UNITED STATES PATENT AND TRADEMARK OFFICE

| APPLICATION NO. | FILING DATE | FIRST NAMED INVENTOR | ATTORNEY DOCKET NO. | CONFIRMATION NO. |
|----------------------------------|-------------|----------------------|---------------------|------------------|
| 10/664,557 | 09/19/2003 | Kevin McMains | LGPL.104360 | 4596 |

| Office Action Summary | Application No. | Applicant(s) | |

DETAILED ACTION

Fig. 4

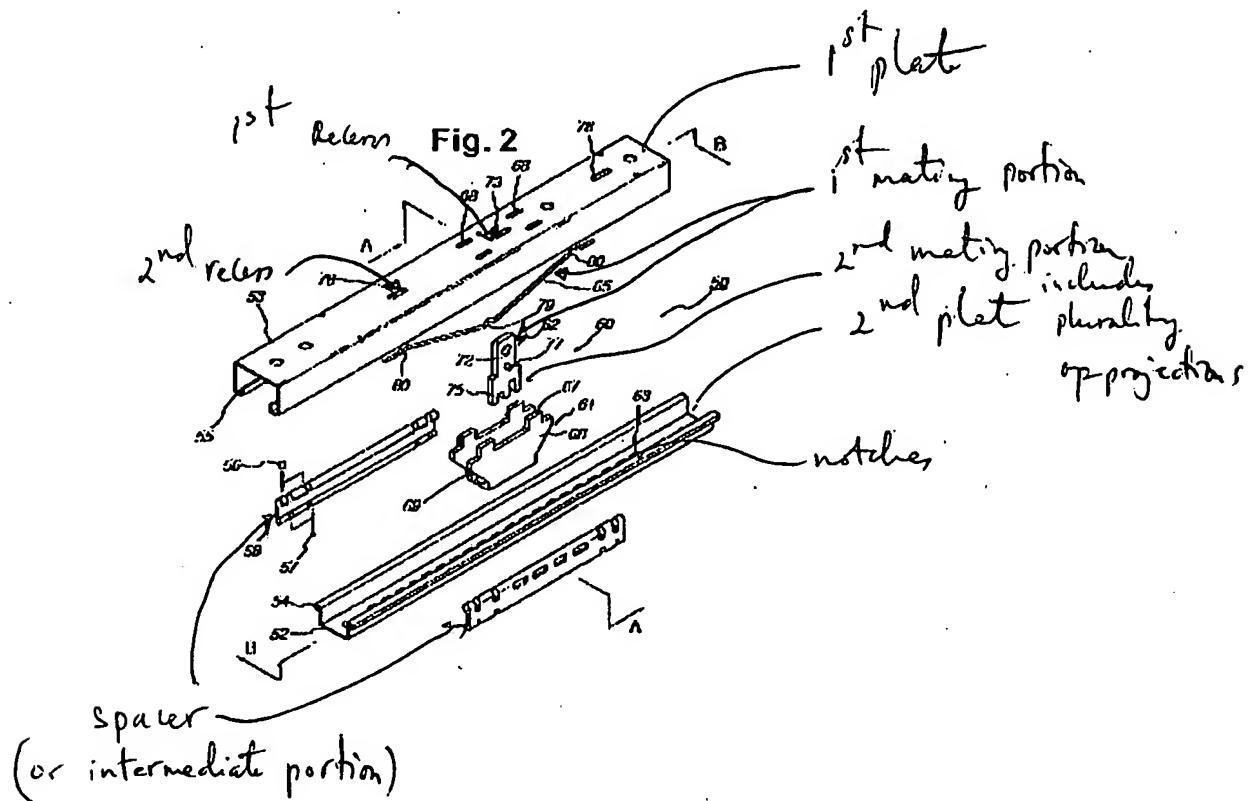
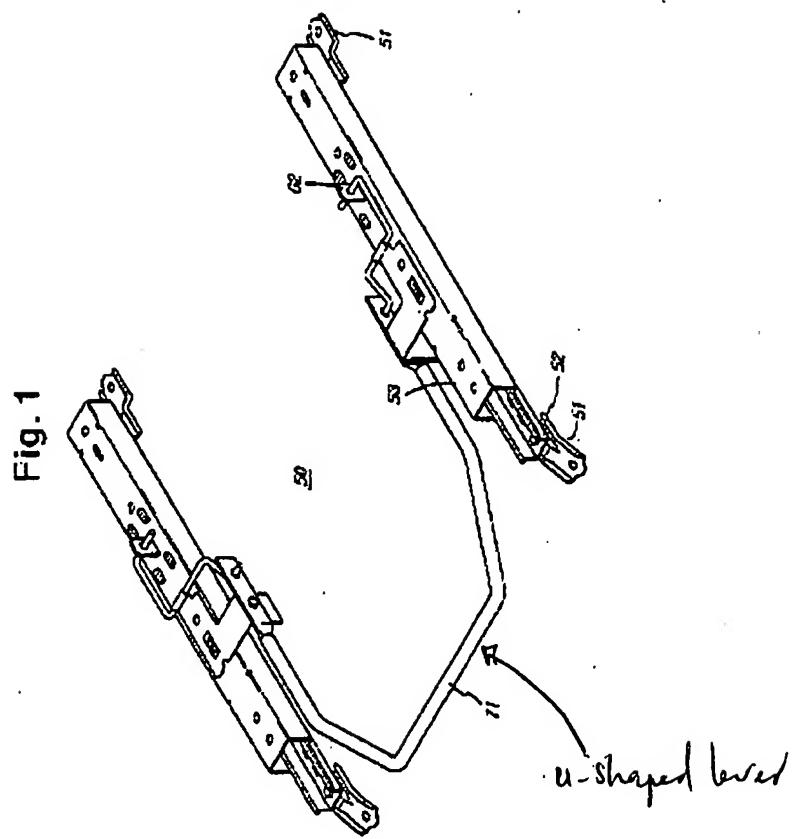
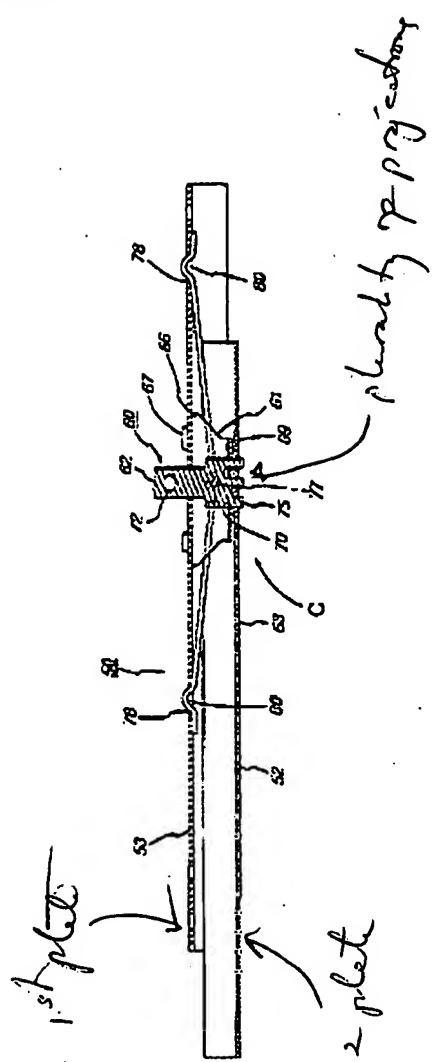
Claims 21 and 23 read on Lee as follows: Lee discloses an adjustment mechanism (Figs. 1-5) comprising: a first plate (53) (see attached figure) adapted to be coupled to a bottom surface of the seat; a second plate (52) adapted to be coupled to an upper surface of the tilt control mechanism, said second plate being slidably coupled to said first plate such that said first and second plates can move relative to one another along the longitudinal axis of the seat; a spacer (58) (also col. 3, lines 61-65), said spacer positioned between said first and second plates for facilitating relative sliding movement therebetween, wherein said first and second plates cooperate to provide a means for selectively adjusting the seat along the longitudinal axis thereof; and a U-shaped lever (71), said U-shaped lever containing a first mating portion (62) adapted to be releasably received in a recess (73) located in the first plate and a second mating portion (75) including a projection adapted to be releasably received in a plurality of notches (63) located on the second plate wherein said U-shaped lever is operable to selectively engage the second mating portion and a selected one of said notches and is operable to selectively release the second mating portion from the selected one of said notches to allow the first plate to move relative to the second plate.

As to claim 33, wherein the first plate includes a second recess (78, for example)

As to claim 34, wherein the mating portion includes first (62) and second mating portions (65, 79, 80), the first and second mating portions adapted to be releasably received in the first (73) and second recesses (78).

As to claim 35, Lee discloses the first (68) and second recess (78) generally rectangular in shape but with round ends. Applicants however, has not discloses that having the recesses with rectangular in shape solves any particular problem or is for any particular purpose. Moreover, it appears that the recesses having rectangular with round ends would perform equally well with the recesses having exactly rectangular without round ends in shape. Accordingly, the use of rectangular in shape is deemed to be a design consideration, which fails to patentably distinguish over the prior art of Lee.

Lee also appears to disclose the first (73) and second recesses (78) located at a midpoint of the first plate.

As to claim 37, wherein the mating projection includes first and second mating projections (see attached figure), the projections being adapted to be releasably received in the first and second set of notches.

As to claim 38, where said first and second mating projections includes a plurality of projections (75).
